Current Zoning: MUDD-O (mixed-use development district, optional) CAC-2 (community activity center – 2), and N2-C (neighborhood 2 – C) Proposed Zoning: UE(EX) (uptown edge, exception)

Approximately 12.04 acres located on the east side of South Cedar Street, west of 4th Street, and north of Mint Street.

The petition proposes to allow for the redevelopment and expansion of the existing Panthers' Practice Facilities and associated accessory uses.

Petition 2024-031 (Page 8 of 8) Pre-Hearing Staff Analysis

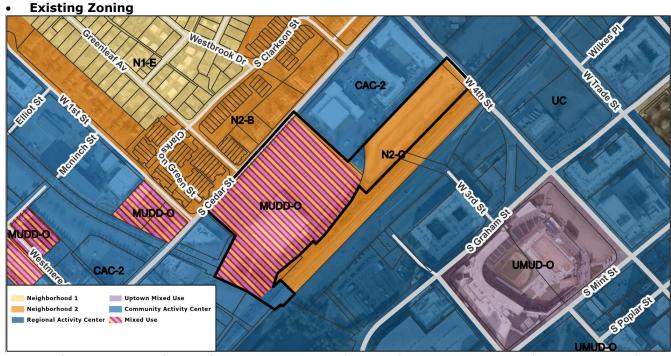
- 4. Revise the proposed EX benefits to list what city improvement, public amenity, or sustainability measure is being provided with details such as which streetscape improvements are being provided that exceed ordinance standards and the square footage, location, and features of the public open space. Add a conditional note stating that the proposed public benefits in this rezoning may not be used to satisfy any public benefit requirements for future rezonings.
- 5. Remove notes B and C under the EX provisions that notes which standards can be modified through an EX request since the language incorrectly references standards that cannot be modified with an EX request.

- 6. Add a proposed maximum building height for Development Area B.
- 7. Add details clarifying which proposed standards may be met on the stadium portion of the property in explicit and clear language.

- 8. Clarify if the EX provision for Article 12.3 regarding minimum building length standards is being sought for all frontages.
- 9. Clarify if the EX provision for Article 12.3 regarding transparency standards is being sought for all frontages.

- 10. Remove the EX provision for Article 16.2 regarding exterior lighting if no modifications to the zoning standards are proposed.
- 11. Modify the EX provision for Article 19.3 to propose a new maximum distance from the entrance where the bicycle parking will occur.

- 12. Modify the EX provision for Article 19.6 regarding the design of surface parking and parking lots. As written, the standard being modified is not a quantifiable standard nor is the proposed modification quantifiable.

- 13. Remove the EX provision for Article 19.7 regarding the design of parking structures as this is not a quantifiable zoning standard that can be modified through EX.

- 14. Add typical cross sections for rideshare areas that would be expected along South Cedar Street and West Fourth Street.
- 15. Modify the EX provisions for Article 22 and section 4 of the conditional notes to remove all language except that which references a master signage package and the commitment to not orient signage towards the residential uses along Cedar Street.

- 16. Modify the EX Provision for Articles 20, 15, and 17 regarding green area percentage requirements in accordance with guidance from Urban Forestry. What is considered built-upon-area must comply with the ordinance.
- 17. Work with Urban Forestry to provide the required tree survey.
